**Addendum 2  
Solicitation 25-008  
Wade Stadium Improvements**

**ADDENDUM 2**

- A. Project Name: Wade Stadium Facility Improvements
- B. Owner: City of Duluth – Property and Facilities Management
- C. Architect: TKDA.
- D. Architect Project Number: 21049.000.
- E. Date of Addendum: December 20, 2024

A201

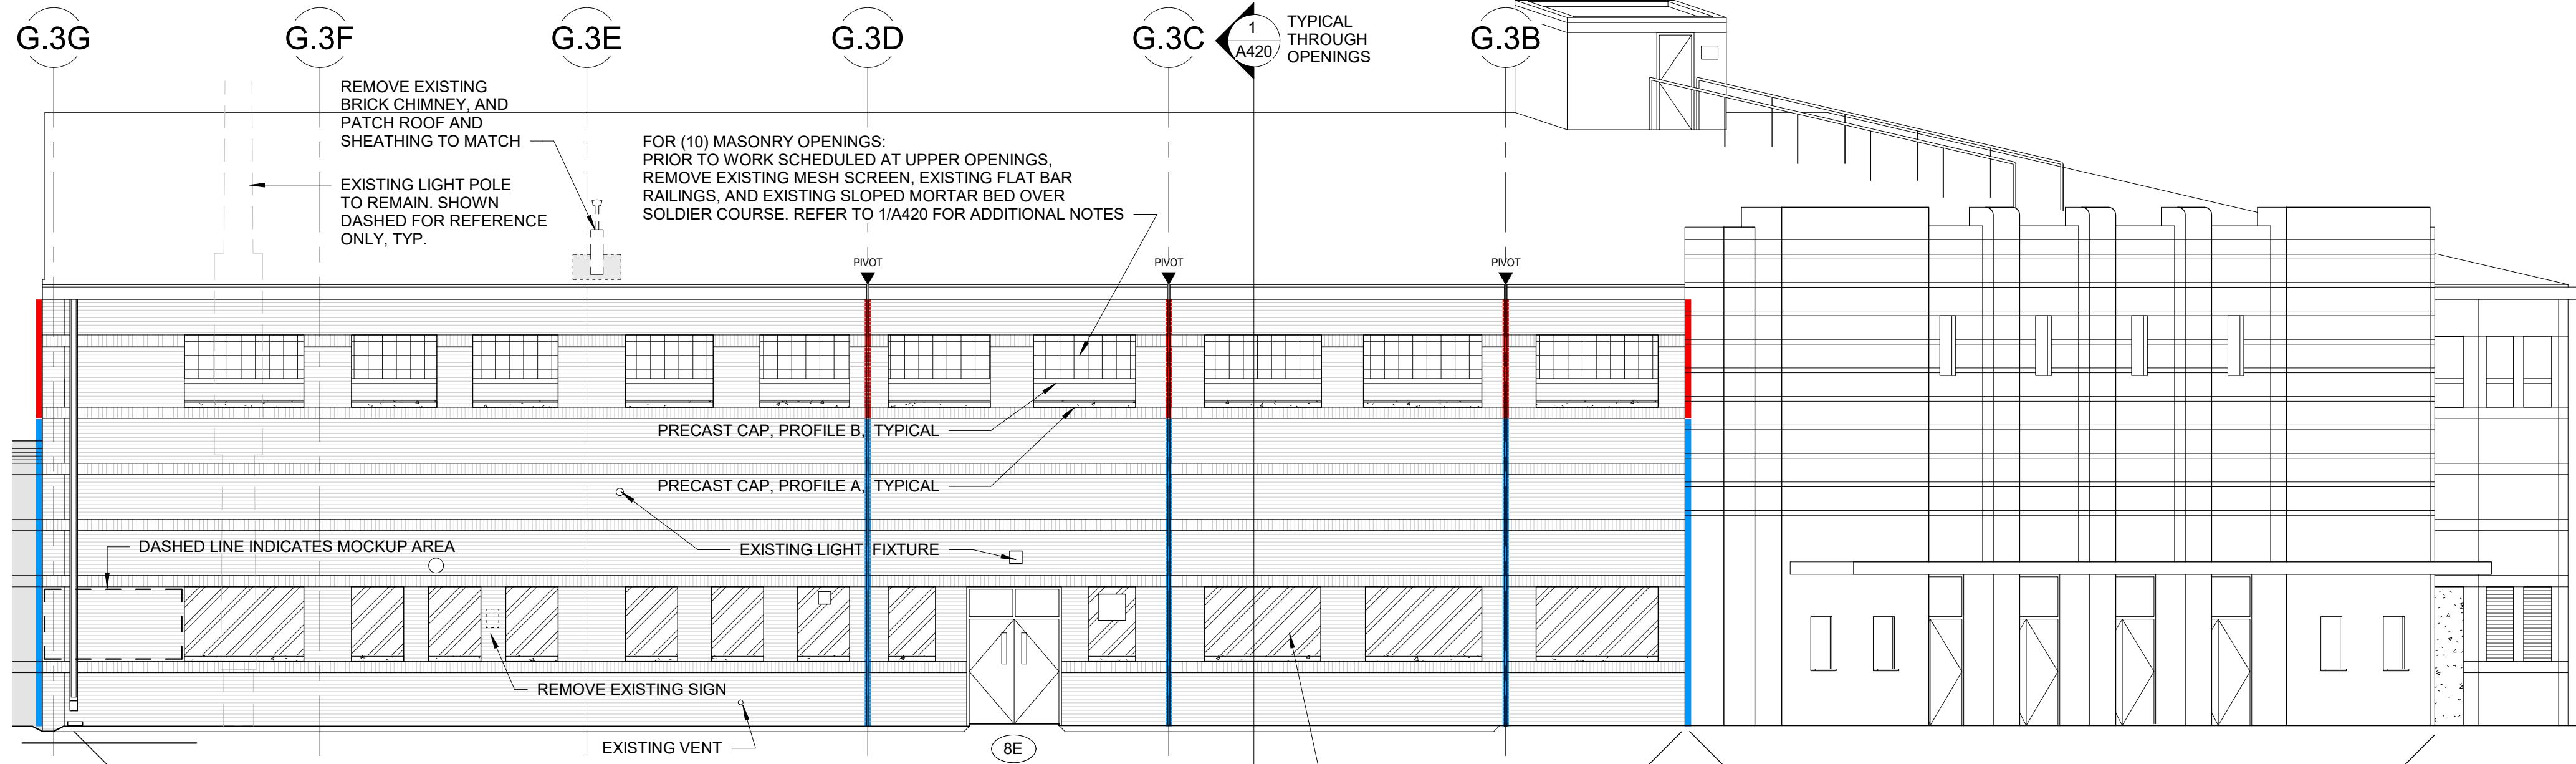
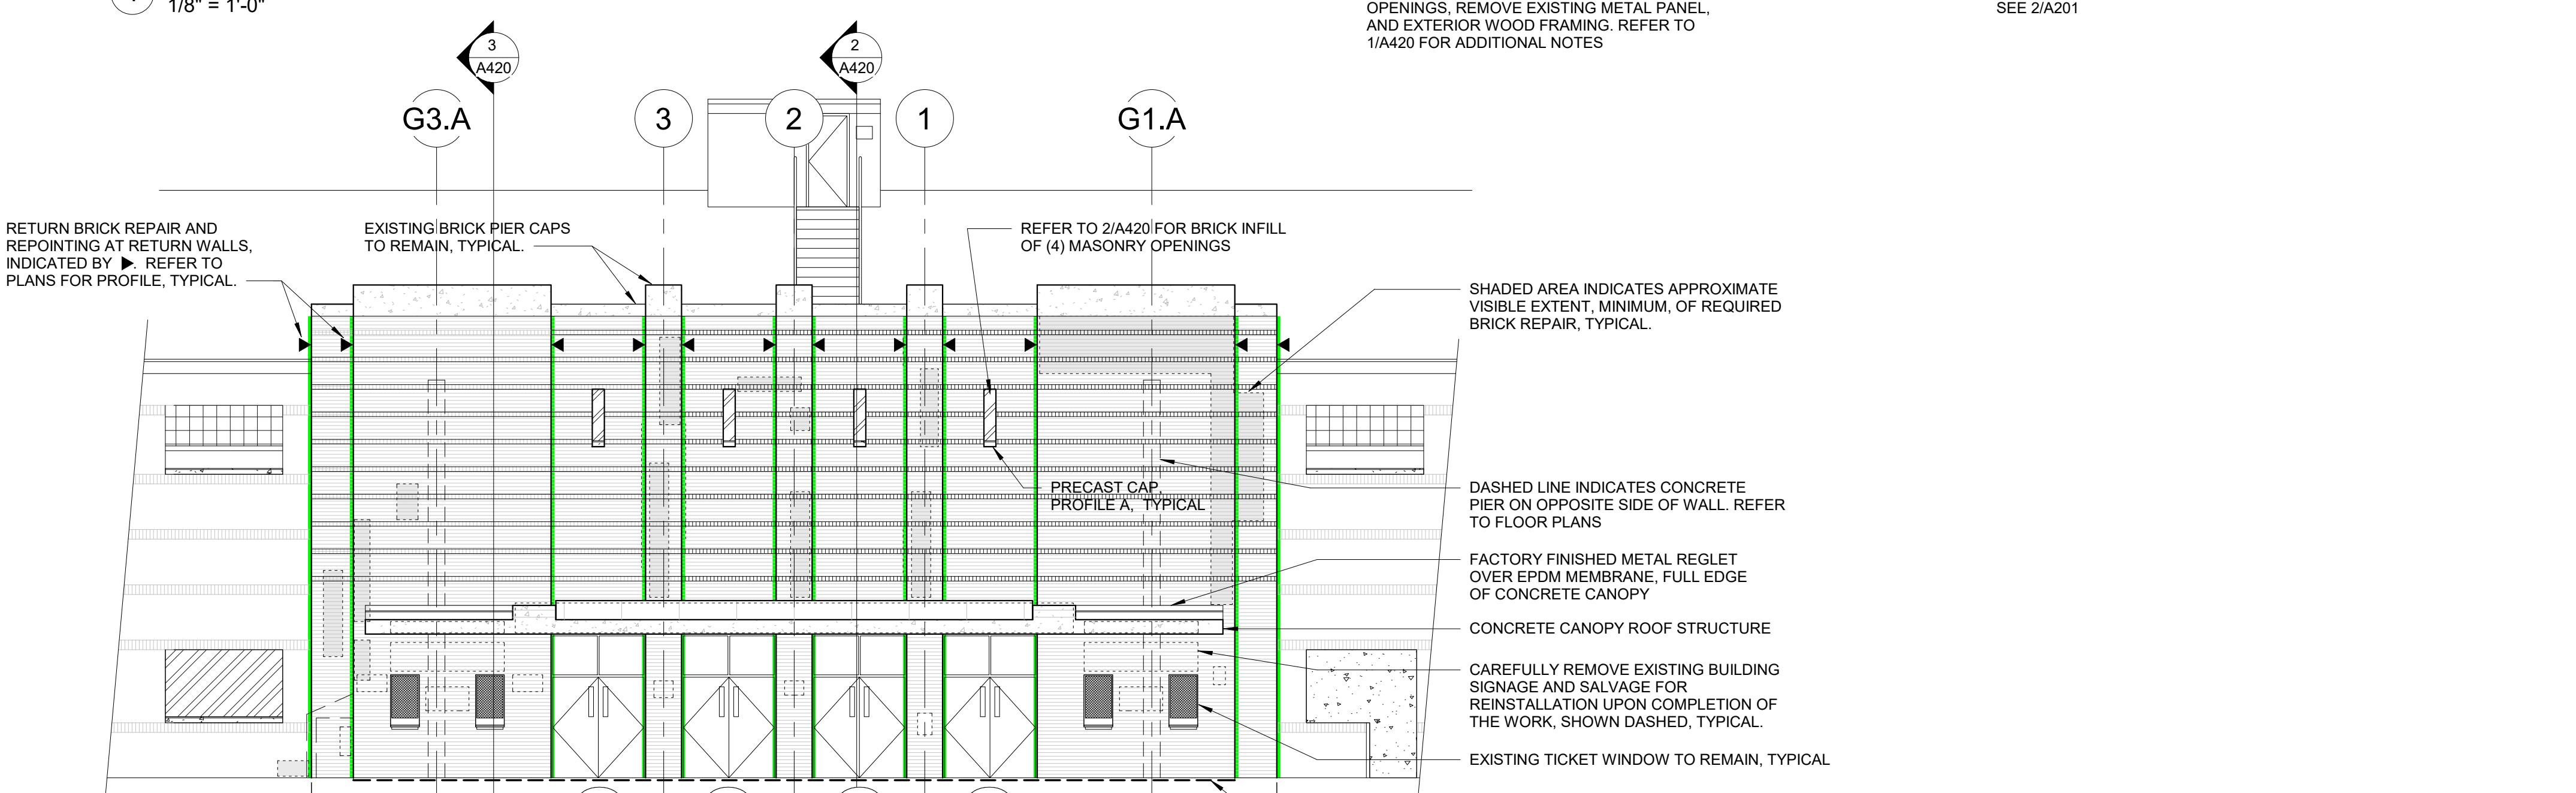
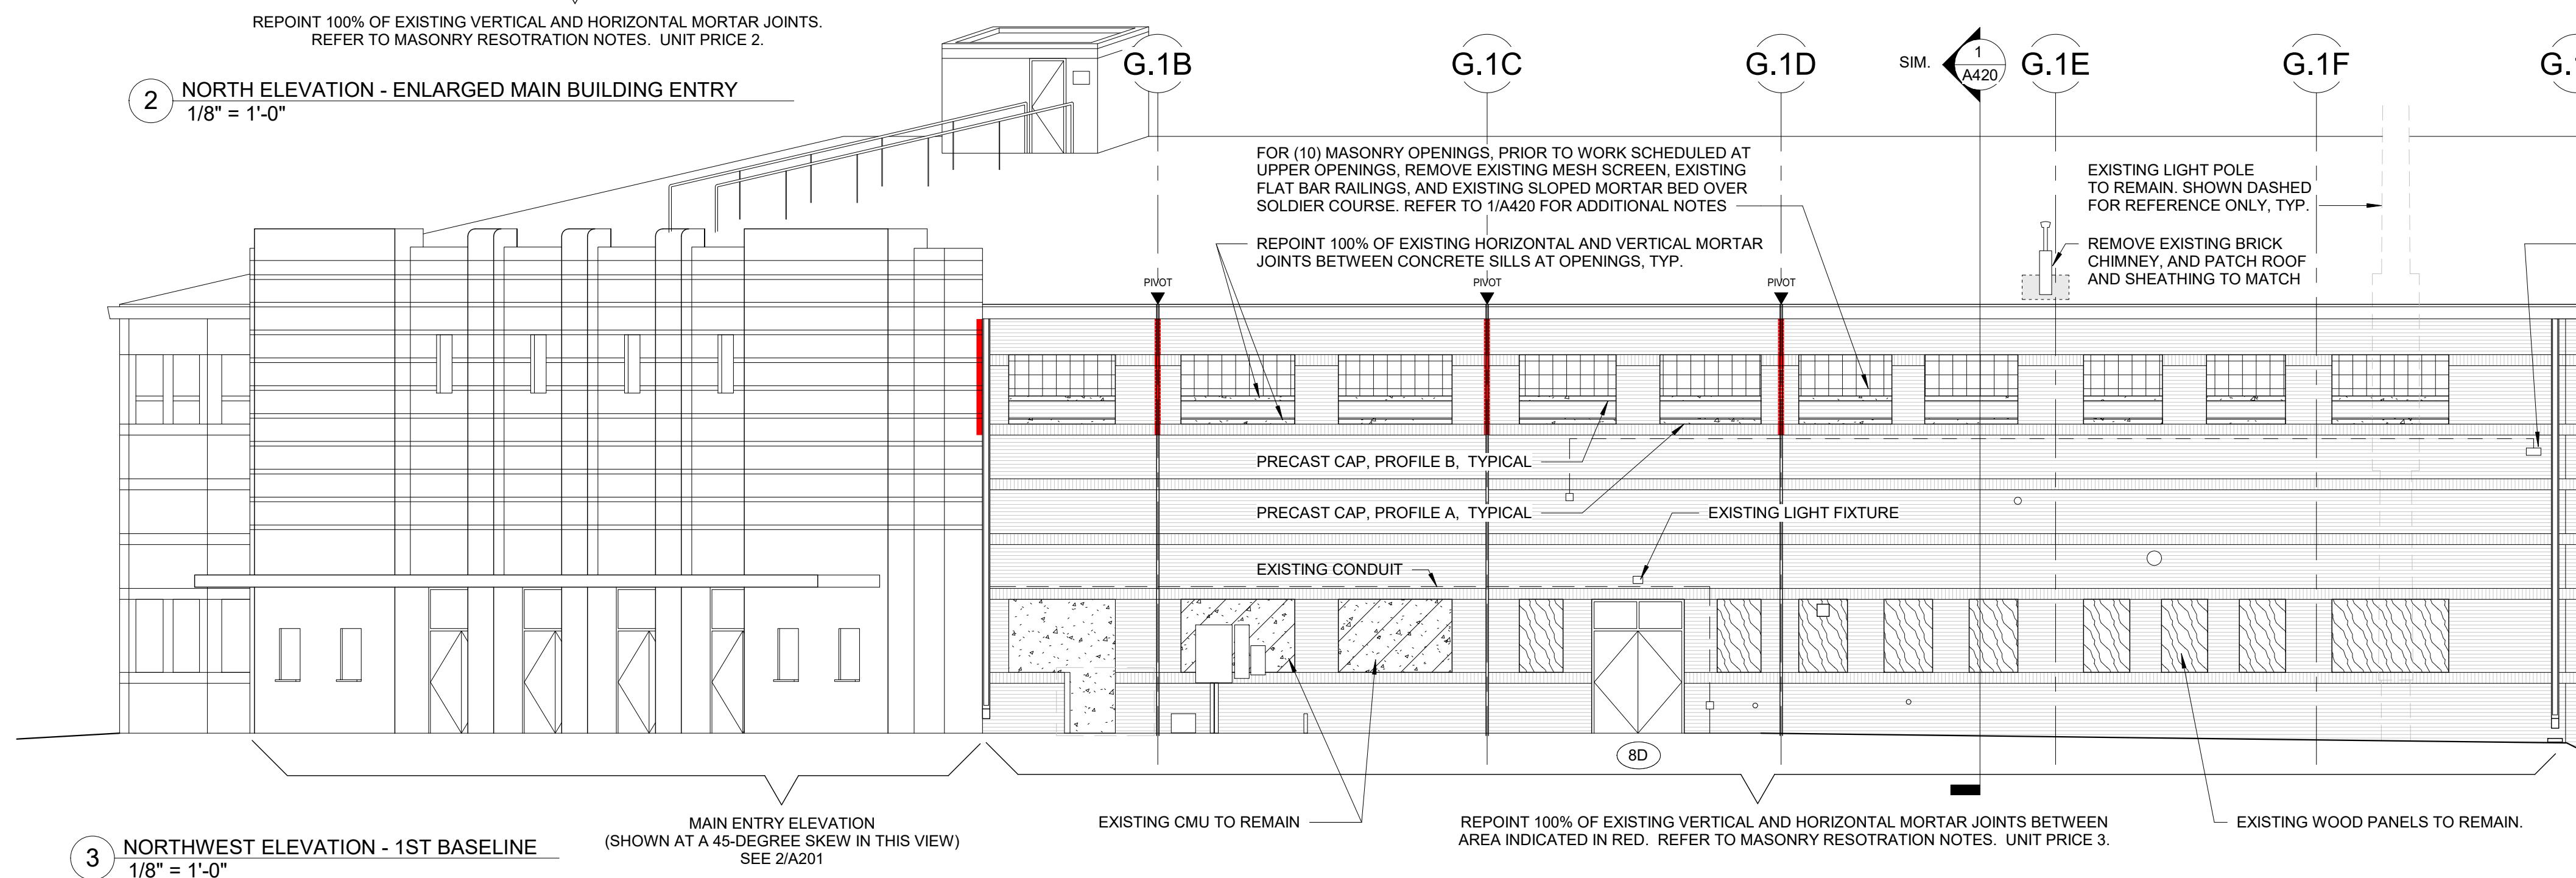
- 2. A201 – Enlarged Exterior Elevations
    - a. Adjusted the Unit Prices to Alternates in Drawing Symbol Legend to align with specification information in 00 43 22 Unit Prices Form.

DRAWING SYMBOL LEGEND			
ROOF PLANS			
►	INDICATES ROOF SLOPE DIRECTION		
<span style="background-color: green;">■</span>	BRICK MASONRY REPAIR AND REPOINTING ALTERNATE 1	<span style="background-color: red;">■</span>	BRICK MASONRY REPAIR AND REPOINTING ALTERNATE 2
<span style="background-color: orange;">■</span>	MASONRY OPENING REPAIR ALTERNATE 3	<span style="background-color: blue;">■</span>	BRICK MASONRY REPAIR AND REPOINTING ALTERNATE 4

A420

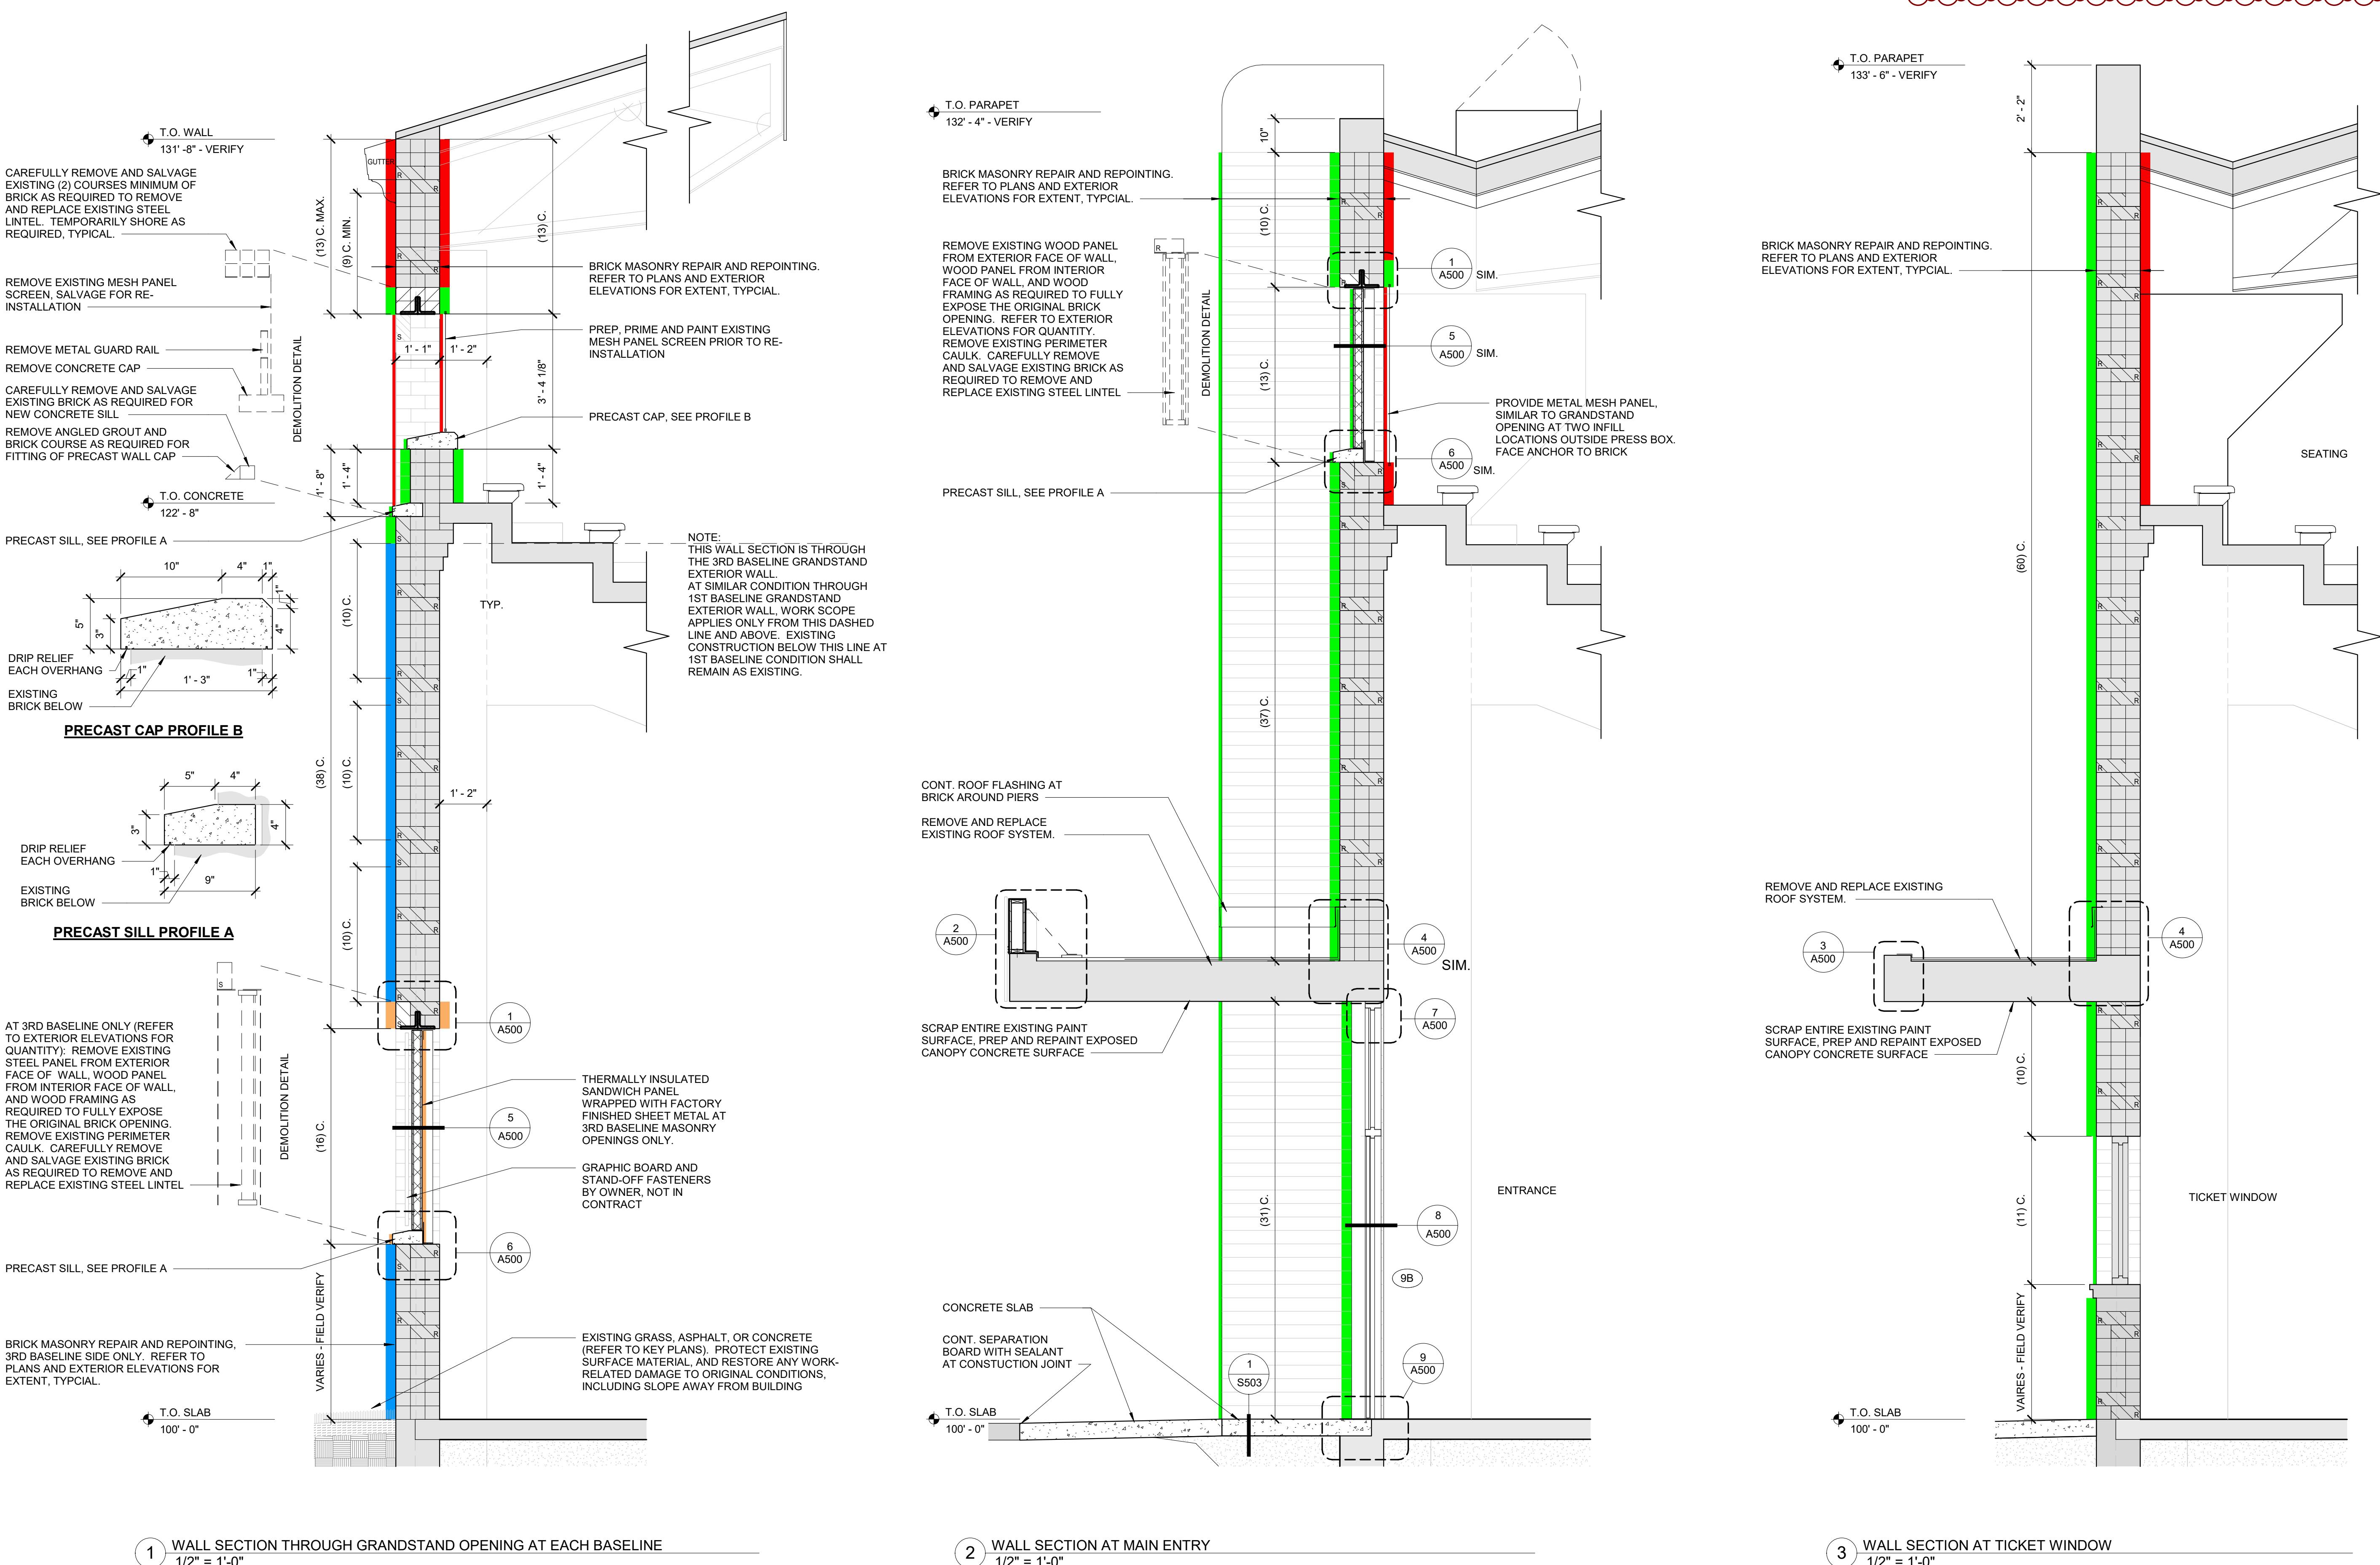
- 3. A420 – Wall Sections
    - a. Adjusted the Unit Prices to Alternates in Drawing Symbol Legend to align with specification information in 00 43 22 Unit Prices Form.
